**STAFF REPORT
HISTORIC AND CULTURAL LANDMARKS COMMISSION
CITY OF FORT WORTH, TEXAS**

REQUEST	Certificate of Appropriateness
APPLICANT/AGENT	Fat Tiger Investments
LOCATION	2109 W Morphy Street
ZONING/ USE (S)	R-1/HC
NEIGHBORHOOD ASSOCIATION	Mistletoe Heights

CERTIFICATE OF APPROPRIATENESS

Proposed Front Elevation

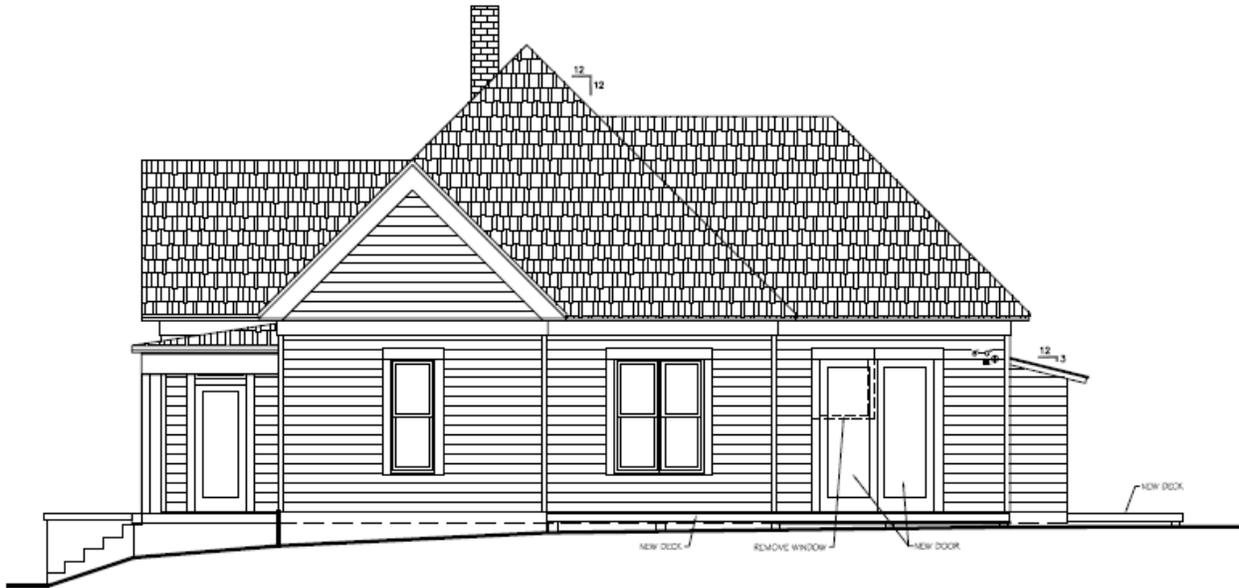
The proposed front doors, however, are not compatible with the predominant historic character of front doors in the District and the proposed relocation of the highly-visible original paired windows at bedroom 2 is inconsistent with rehabilitation principles, which recommend the retention of original openings.

The front porch and stairs may require guard and handrails, which should be confirmed and shown on the elevations as appropriate. Further, in relation to the drawings, shutters that are proposed to be removed should be depicted as such on the elevations. The roof on the left elevation above the paired windows is drawn as a gable roof, however, it is a hipped roof, more accurately depicted in the front and rear elevations. The storage/garage needs to show the extent to which the existing garage is to be retained and rebuilt. The elevations need to show the existing decorative metal porch posts and the extent to which the original wood siding will be retained.

- 1. That the front doors be consistent with the predominant historic character of front doors in the District;**
- 2. That the 1/1 replacement windows be wood as indicated in the Description of Work section of the COA application rather than metal-clad as depicted in the drawings;**
- 3. That the original opening, which houses the paired windows in the proposed bedroom 2, be retained in its current position; and**
- 4. That the drawings be revised and updated to reflect the above conditions and findings.**
